T1.New Maintenance Operations Center.Urgent
(Project Name)

GTAA BMS OFFICE RENOVATION

SUBSTANTIAL COMPLETION SITE VISIT REPORT

GTAA TORONTO PEARSON AIRPORT

Figure 6 - View of monitor wall as-built condition at site.

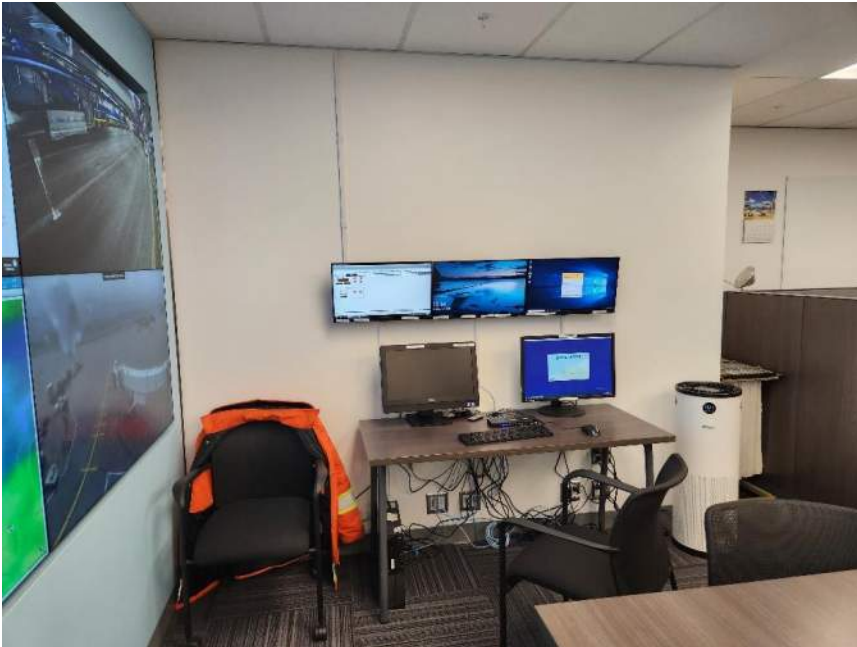
The monitor wall was not in conformance with the design. The CACF room had a missing fire-rated caulking tag/label at the ceiling mounted make-up air mount/threaded rod penetration through ceiling. Refer to site photos in deficiency list.

Figure 9 - Minor damage noticed at GWB wall corner edges.

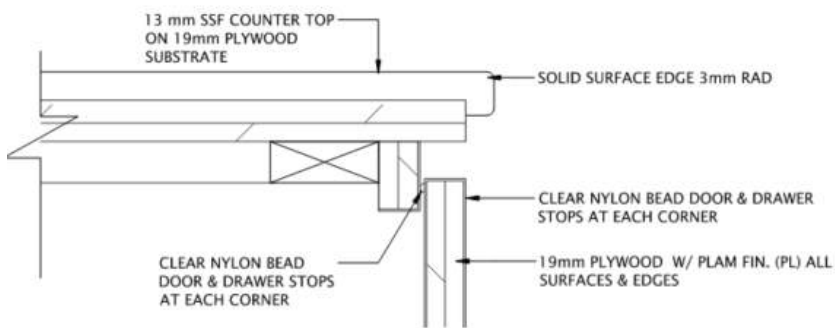
Comments: Consider installing a PVC or stainless-steel corner guard to protect exposed GWB corner from future damage.

Figure 21 - Specified P-Trap Approved Submittal

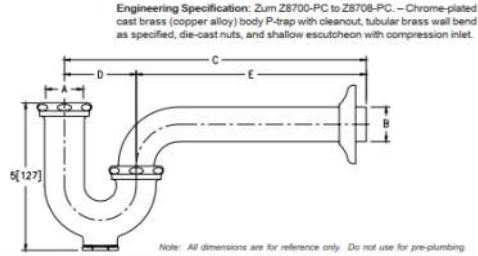
- ❖ The P-trap supplied for the sink deviates from the specifications delineated in the approved submittal (refer to **Figure 21 - Specified P-Trap Approved Submittal** and **Figure 22 - Installed P-Trap** below).

Figure 23 - Approved submittal for MAU staging filter to be provided by contractor

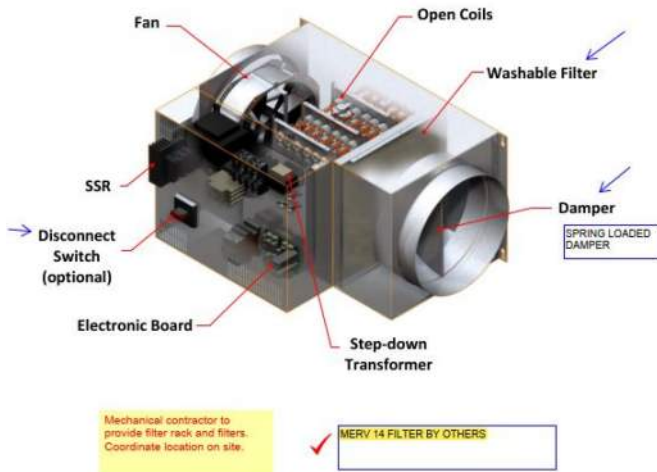
- ❖ The filter and its corresponding rating for the Makeup Air Unit (MAU-1) could not be located and verified. Please provide clarification (refer to **Figure 23 - Approved submittal for MAU stating filter to be provided by contractor** below).

Figure 24 - Manufacturer's Installation Requirements for MAU-1

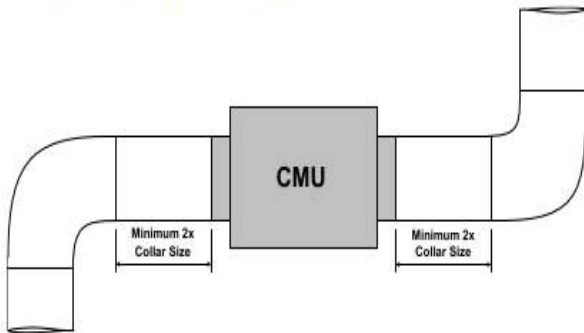
- ❖ Confirmation of the connection between the fresh air ductworks and the new MAU-1 was impeded by the sealed ceiling. Kindly provide relevant construction photographs.
- ❖ Verification of the fire smoke damper and its associated connections was hindered by the inaccessible ceiling. Please supply any pertinent construction images for assessment
- ❖ It appears that the installation of the Makeup Air Unit (MAU-1) does not conform to the manufacturer's installation requirements (refer to **Figure 24 - Manufacturer's Installation Requirements for MAU-1-1** and **Figure 25 - Site Installation of MAU Ductwork Not Conforming to Manufacturer's Instructions** below).

- For proper air flow, a minimum straight duct distance of 2x the collar size/duct diameter must be maintained upstream and downstream the CMU, between the unit and any obstacle, such as dampers, louvers and elbows.
- Use round insulated ducts for the inlet connection and uninsulated ducts for the outlet, while ensuring to minimize the use of elbows.
- When taking air directly from outside, install the inlet duct at an incline, in order to prevent condensation or melted snow from flowing into the unit.
- It is recommended to have a secondary damper before the inlet of the make-up air unit, in order to prevent a strong draft of wind from opening the damper in the unit. The secondary damper can be a gravity damper or a damper with an actuator.
- A louver with a bird protection grille must be installed on the air inlet.

Figure 26 : Modified duct and terminals arrangement

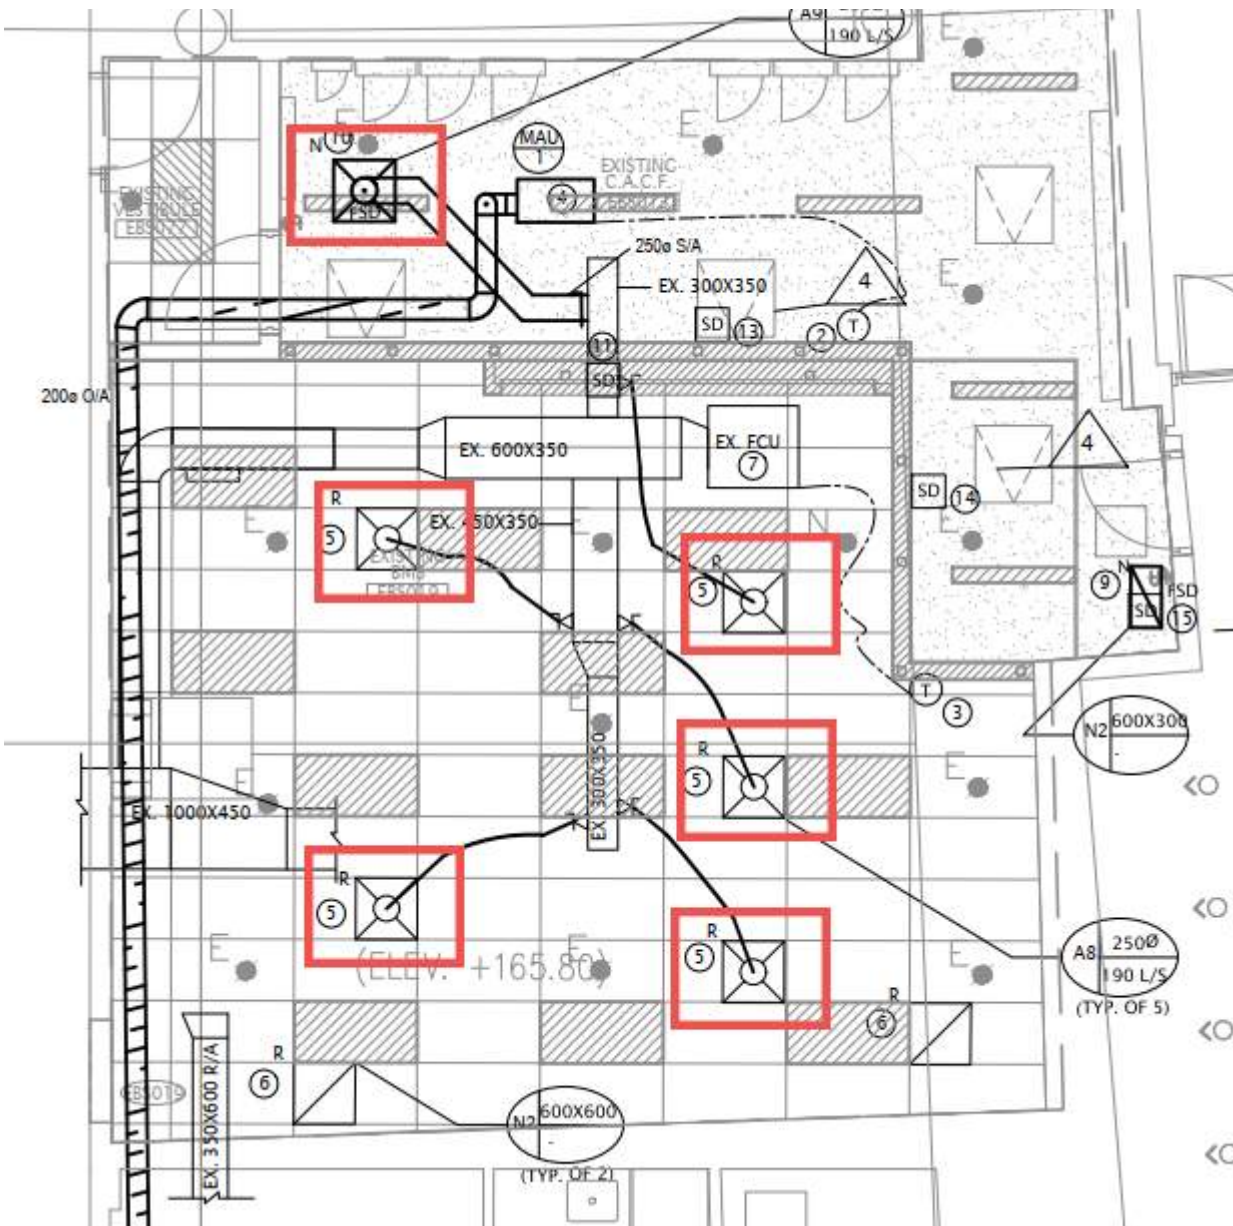
- ❖ Verification of the damper and bird screens on the supply side of the Makeup Air Unit (MAU-1) was not possible due to access limitations. Please submit any relevant construction photographs for examination.
- ❖ Provide the testing and commissioning report for MAU-1. Also, confirm if the MAU has been configured with the BAS.
- ❖ Provide the testing and balancing report for modified duct work. Refer to figure 35 below.
